GATE, S.N. 443,300

R E M A R K S

Figure 1

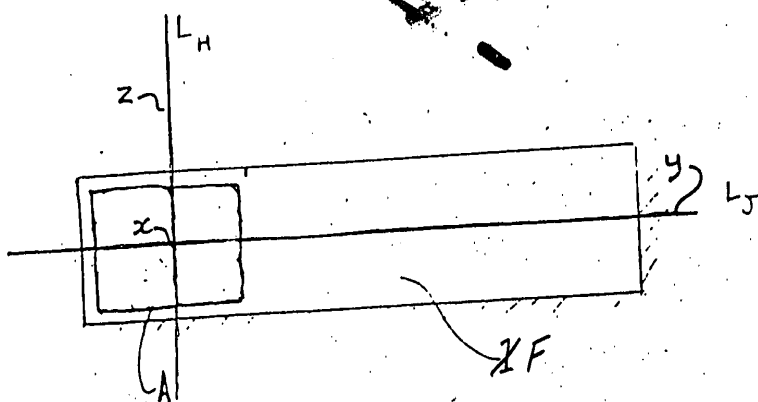
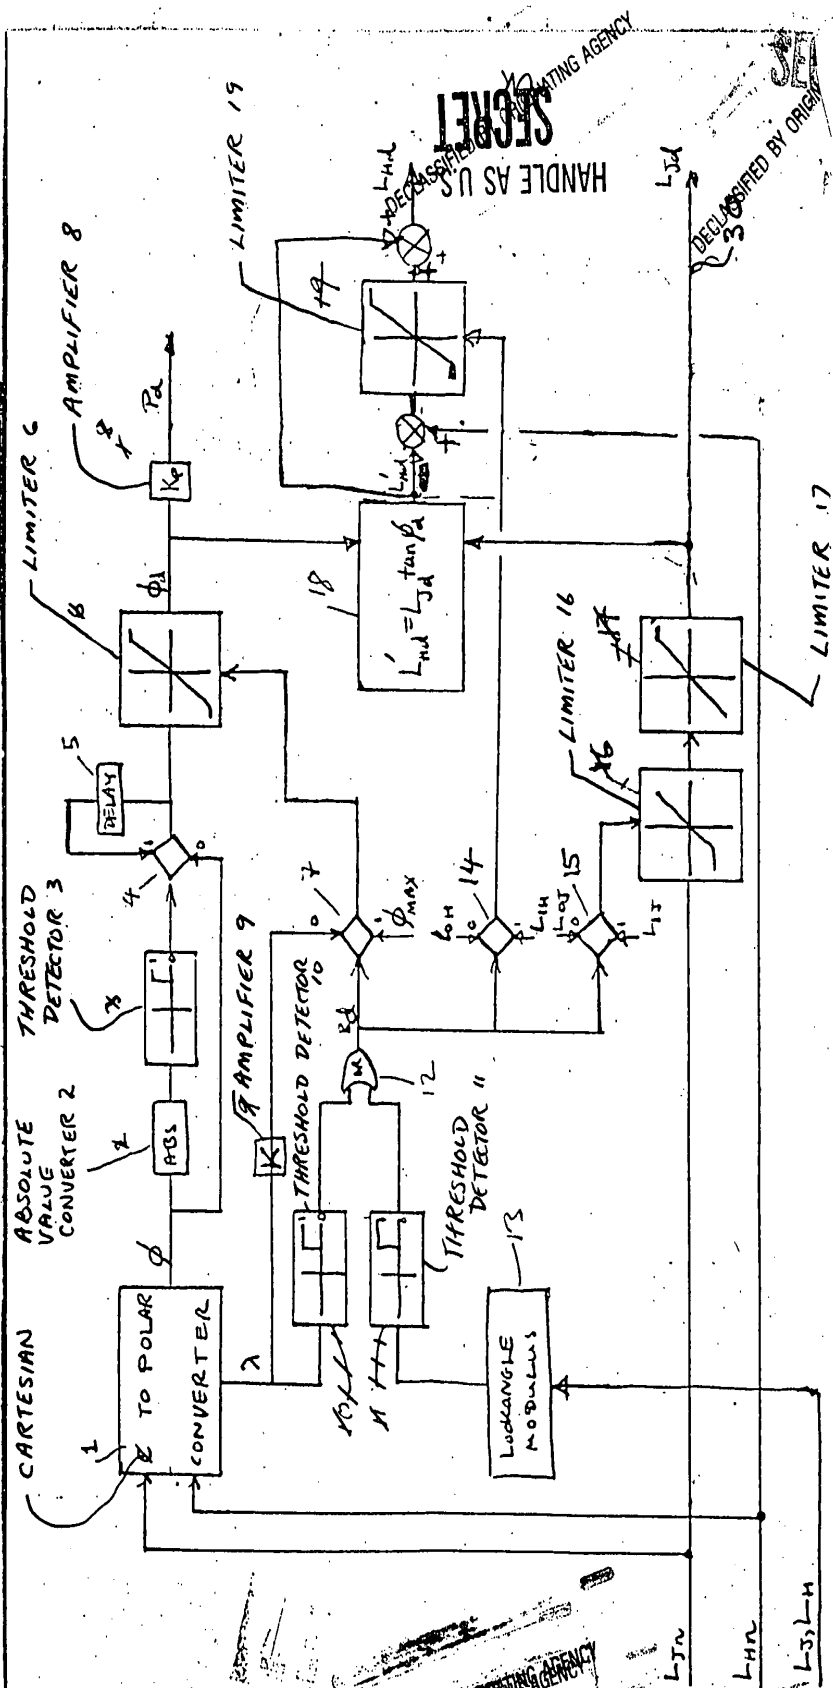
The drawings were objected to because in Figures 1 and 2 the numeral "1" denoted two different elements and the rectangular blocks in Figure 2 were unlabelled. By separate paper filed herewith entitled "Request for Approval of Drawing Corrections", drawing corrections are requested for overcoming these objections.
